# TECHNICAL NOTE

REF: 301404162

DATE: 22 December 2021

### PARKSIDE YERONGA – COMMERCIAL DEVELOPMENT PROPOSAL

Figure 3: Performance Solution – Vehicle Access Sight Distance

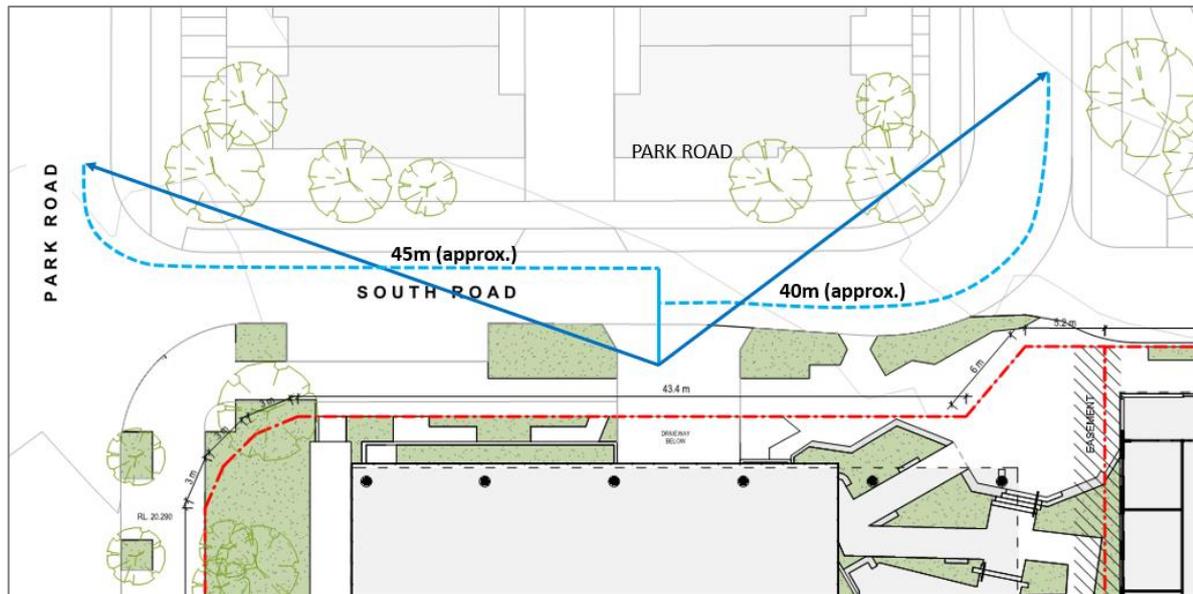
Stantec has prepared sight distance diagrams to demonstrate the available sight distances at the proposed vehicle access locations, as shown in Figure 3. The vehicle access location provides unrestricted sight distance to the east (internal street network curvature) of approximately 40m and to the west (left-in / left-out intersection with Park Road) of approximately 35m.

Guidance has been sought from the relevant Australian Standards (AS2890.1) and Austroads Guidelines (AGRD 03) having regard for the road geometry and the internal street network curvature which an inner radius in the order of 11m and an outer radius in the order of 25m. Interpolation of Section Operation Speeds

detailed in the relevant Austroads Guidelines (AGRD3 - Table 3.4), these radii correspond to a design speed of approximately 30kmh.

This design speed results in a reduced Stopping Sight Distance (SSD) requirement of approximately 25m. As such, the sight distances are able to be comfortably achieved to the east and west of the proposed vehicle access.

These proposed arrangements are provided in line with relevant standards, guidelines and good transport engineering practice and are therefore considered to be acceptable.

DRAWING TITLE  
**BASEMENT 01 & 02 PLAN**

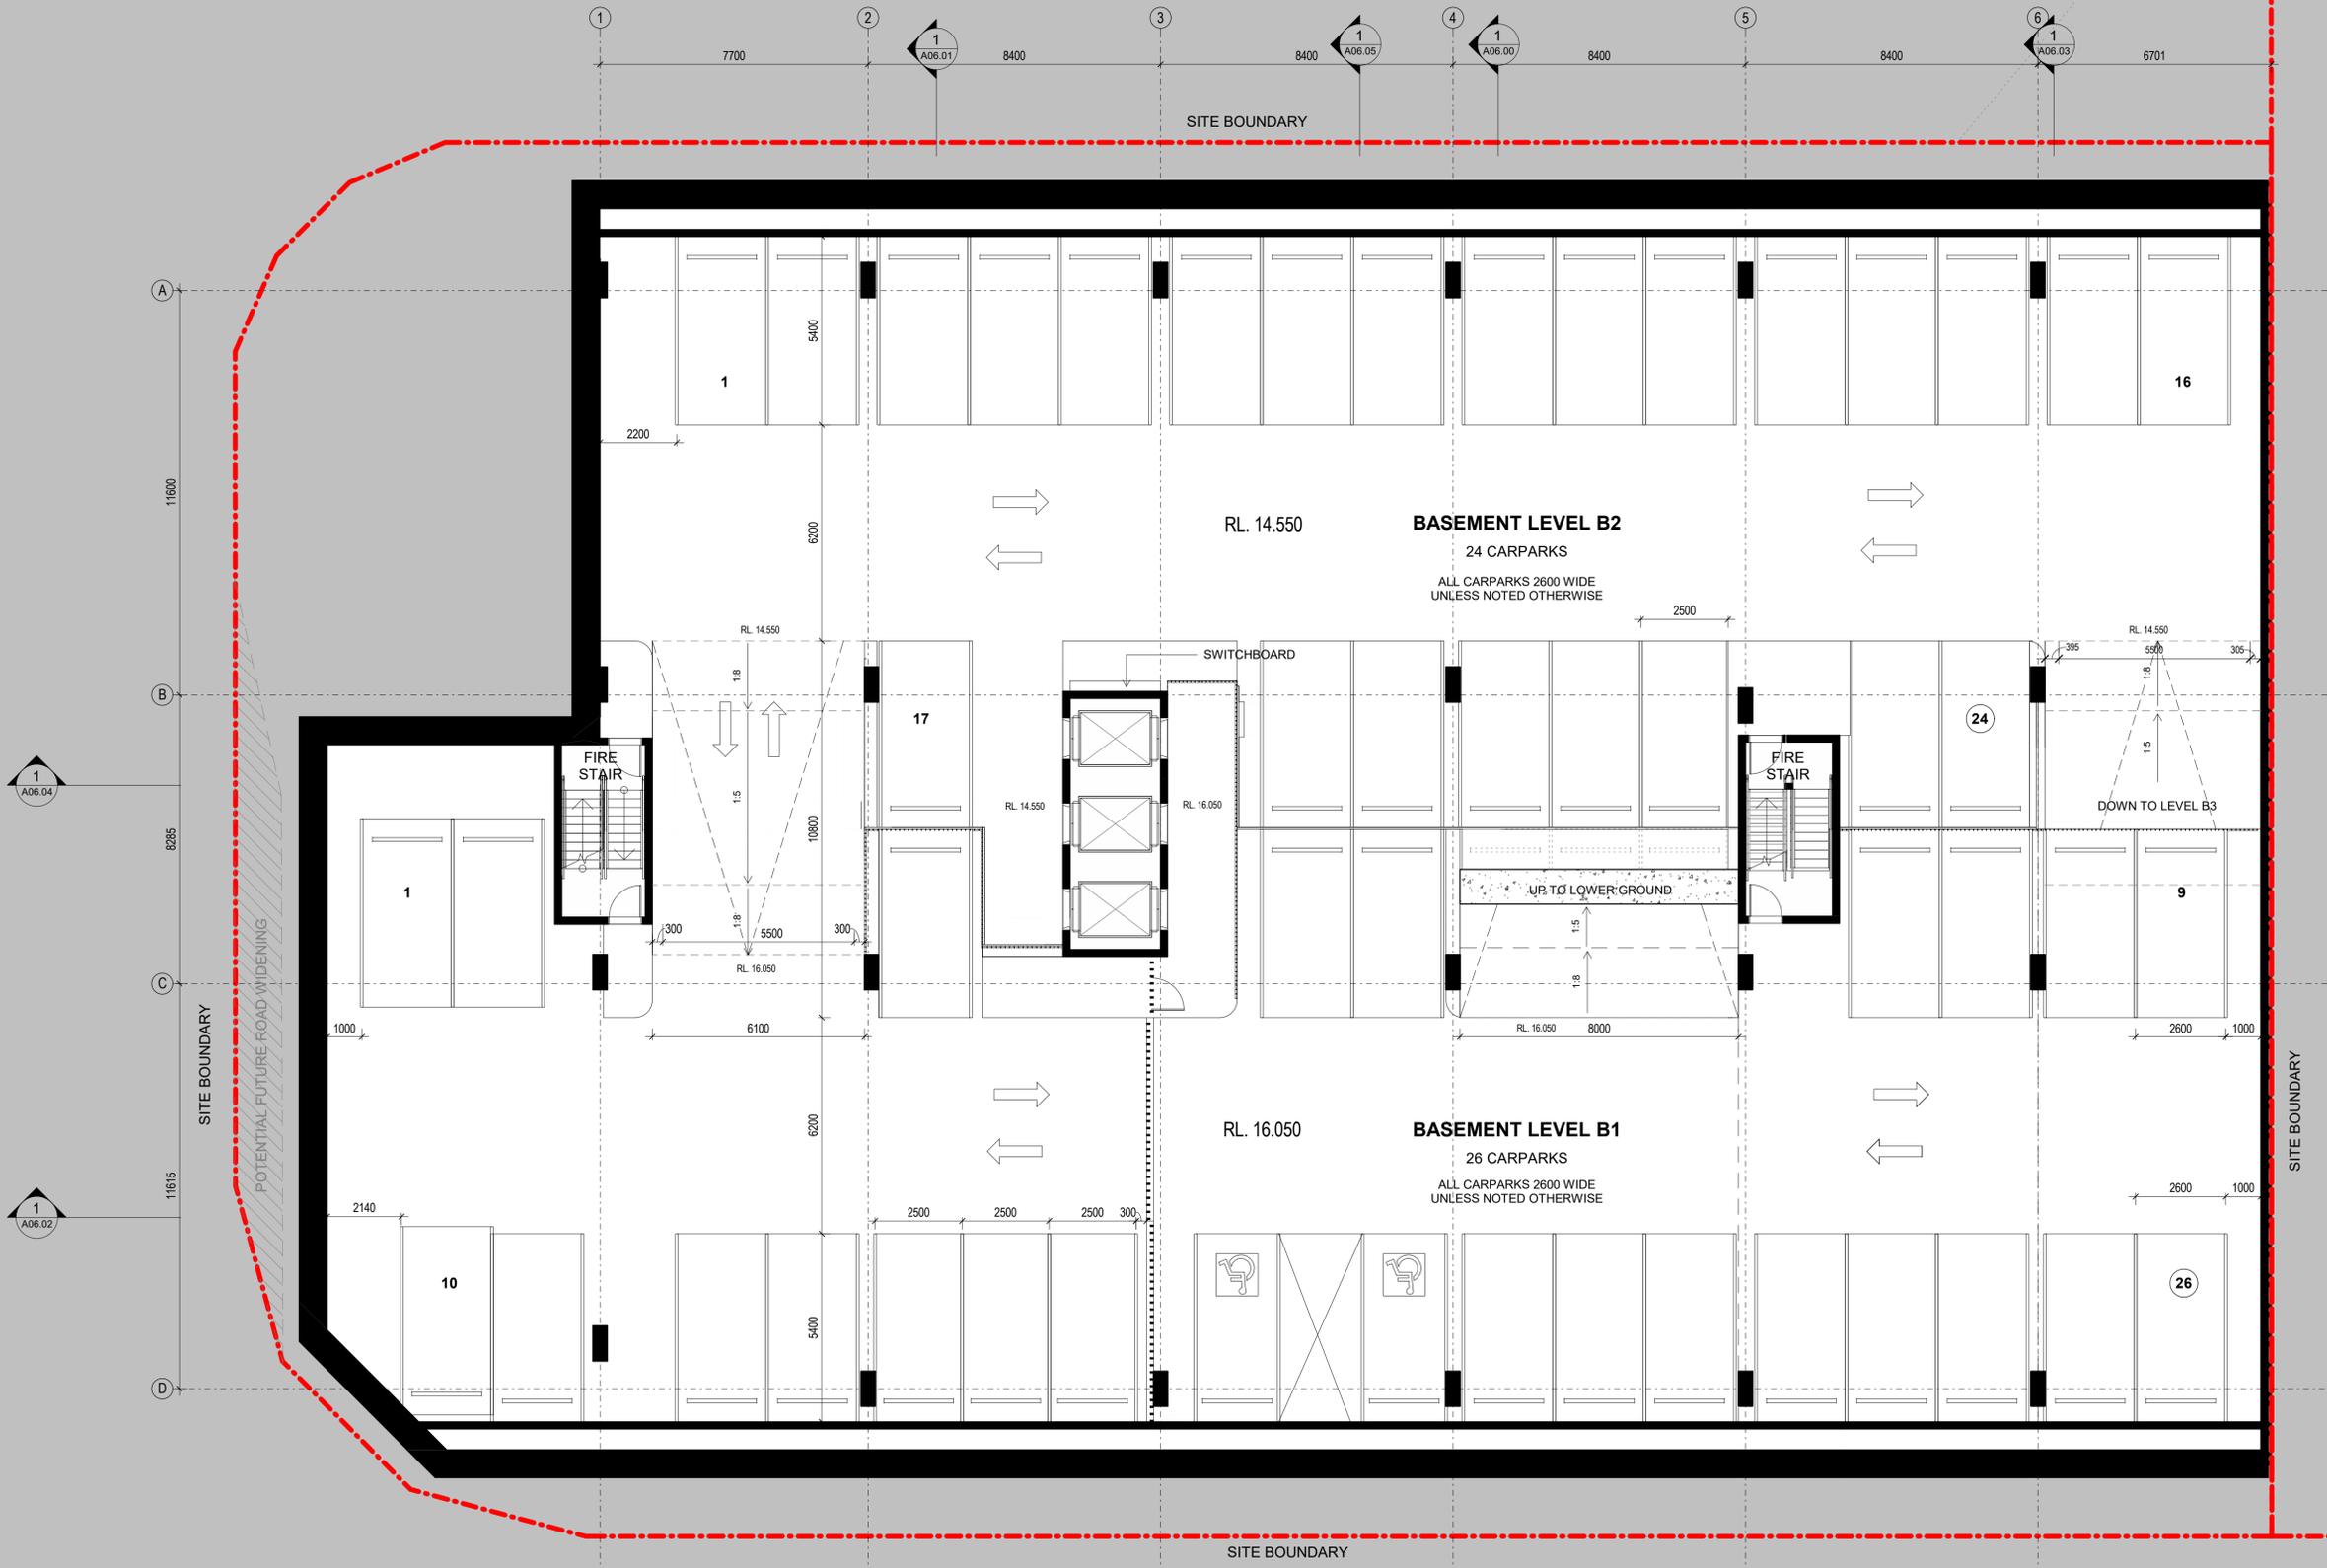
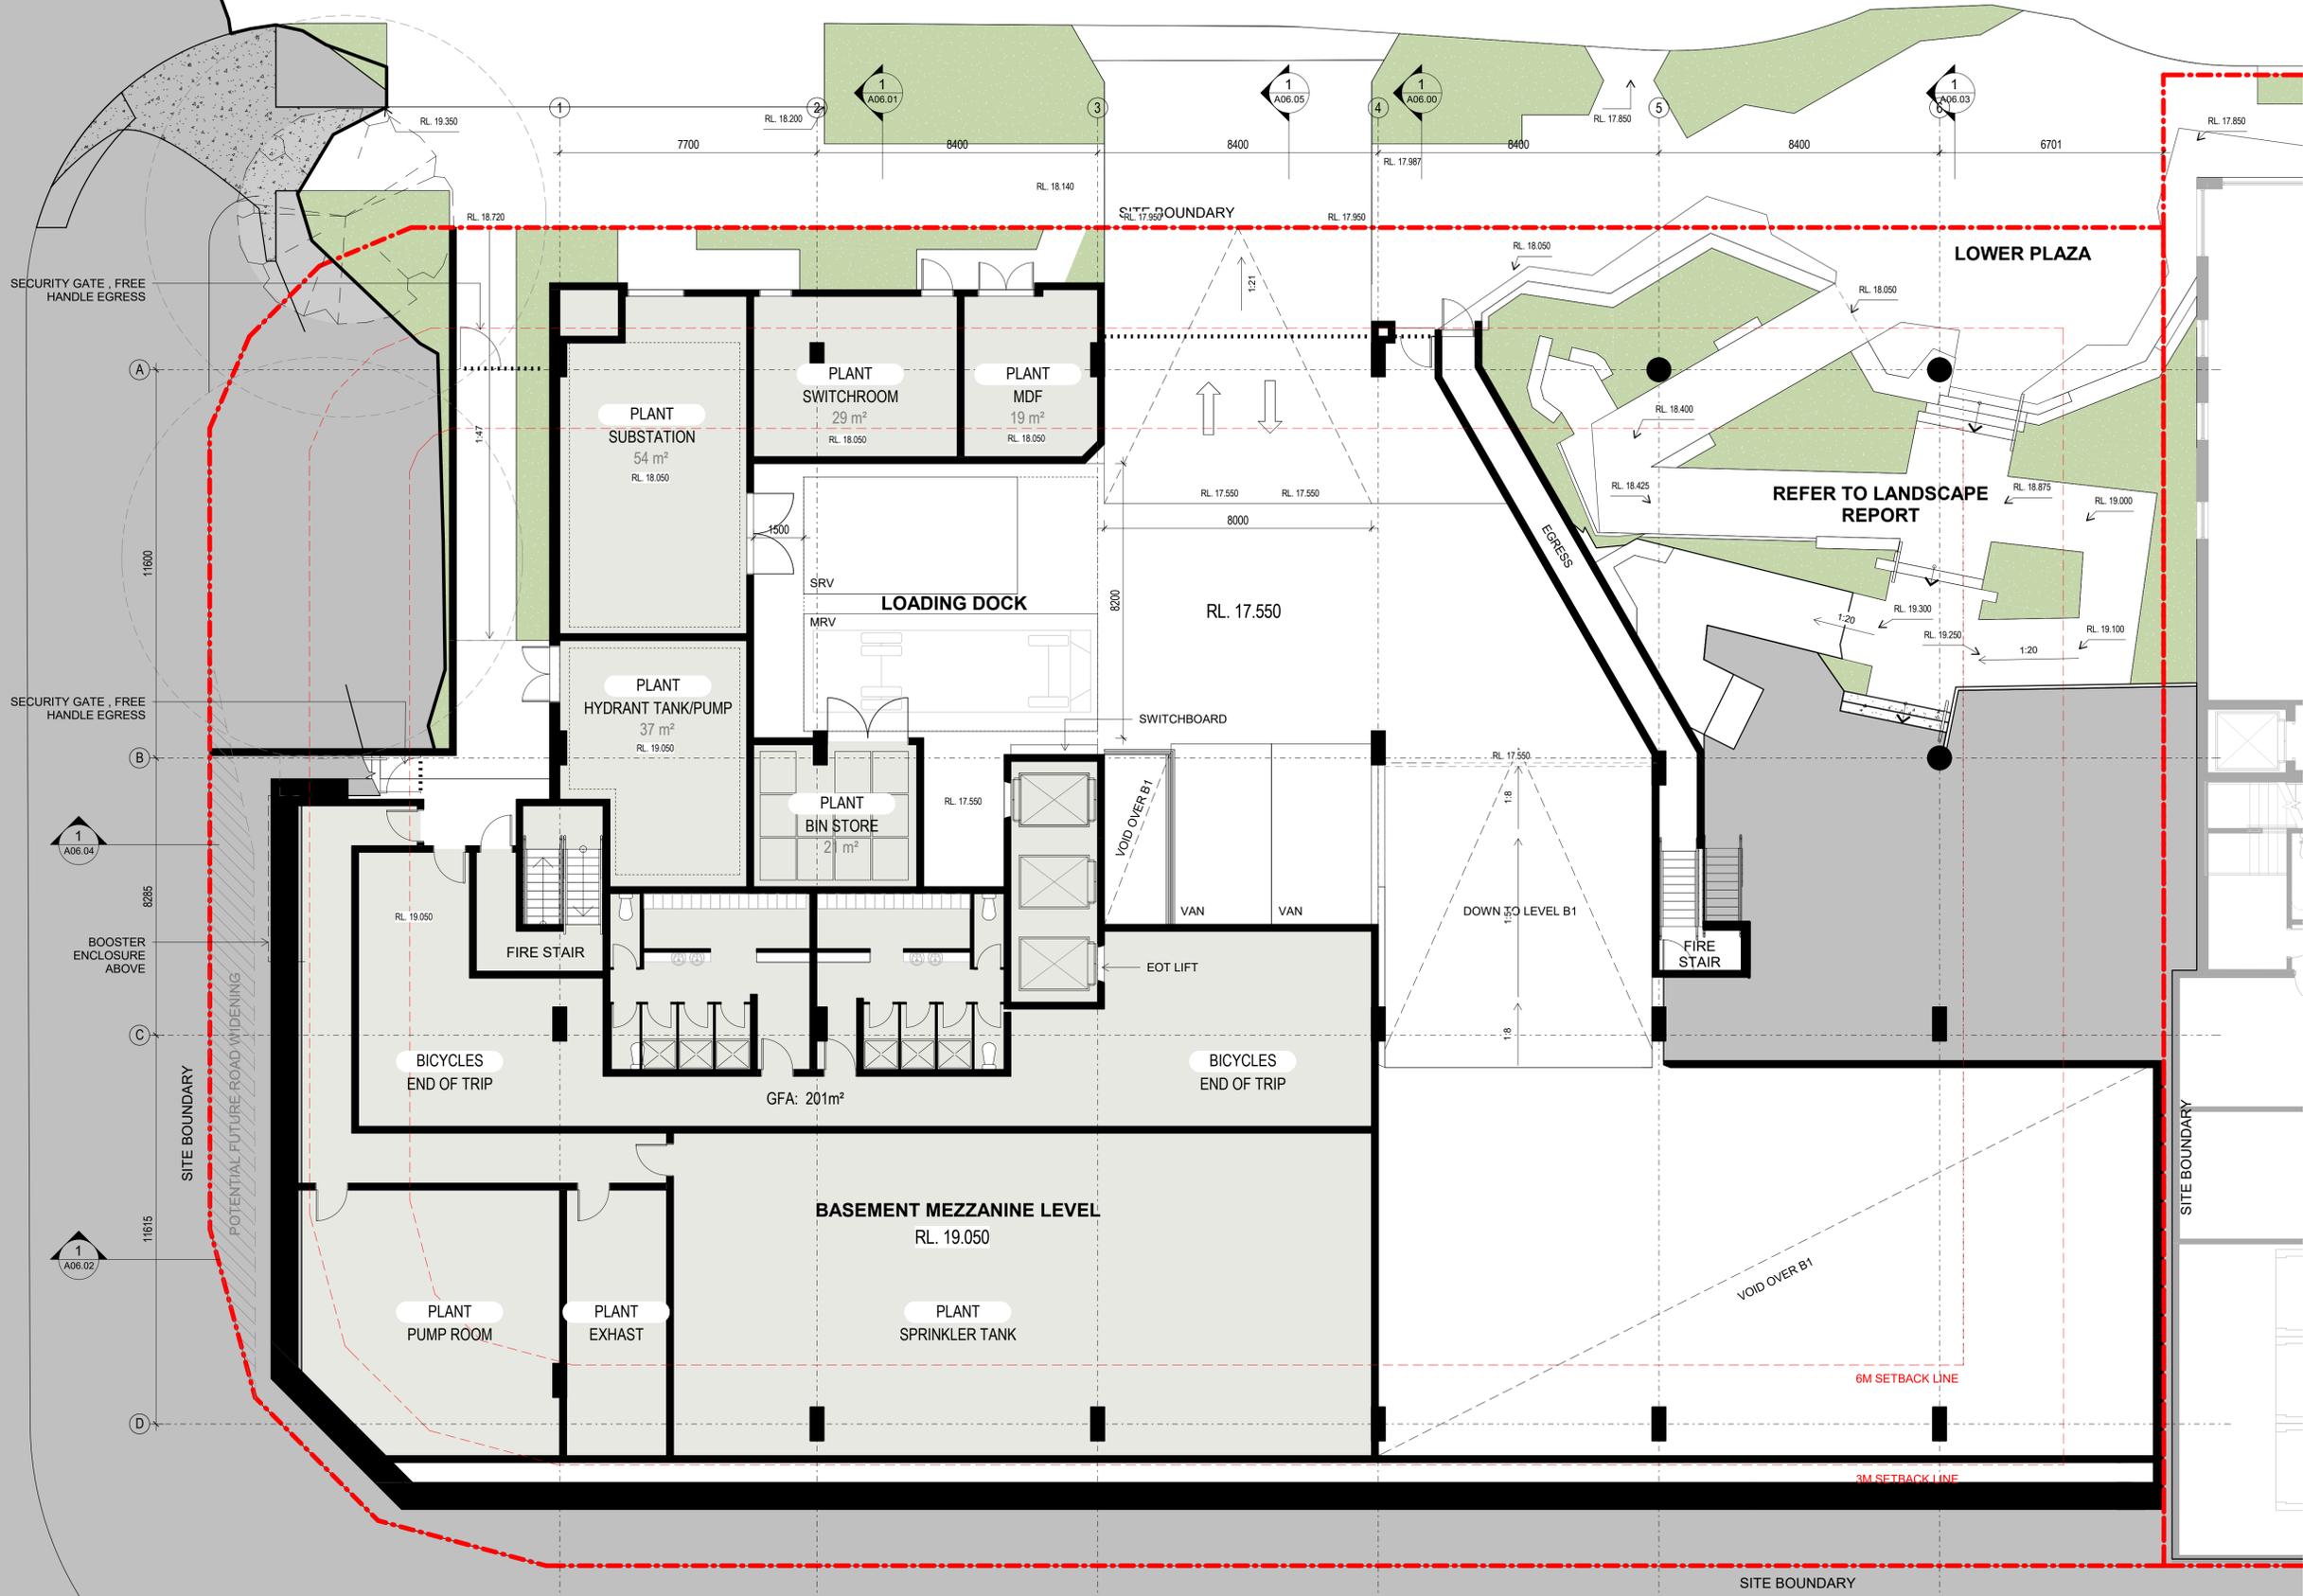
An internal security gate is proposed within the basement car park has been provided to maintain separation between the visitor and staff car parking modules. Whilst details of the form, location and operation of this security gate are yet to be confirmed, an indicative location within the car park has been provided on the basement plans.

Multiple parking spaces provided within the Commercial Development proposal layout maintain columns within the parking envelope, extending 1.8m from the entrance of parking bays (1.75m permitted) and encroaching on the required clearances.

Based on Council’s TAPS PSP and the relevant Australian Standards (AS2890.6), the required vertical clearances throughout the carpark and access locations are 2.3m and 2.5m above accessible car parking bays. Advice provided to Stantec is that there is to be a minimum floor to floor clearance of 3.0m throughout the car parking areas.

It is recommended that parking bays be reviewed as part of subsequent stages of design to ensure the column locations adjacent to parking bays are outside of the required parking envelope, provided in accordance with the relevant Australian Standards (AS2890.1).

Nevertheless, vertical clearances are to be provided in accordance with the requirements of Council’s TAPS PSP and the relevant Australian Standards (AS2890.6).
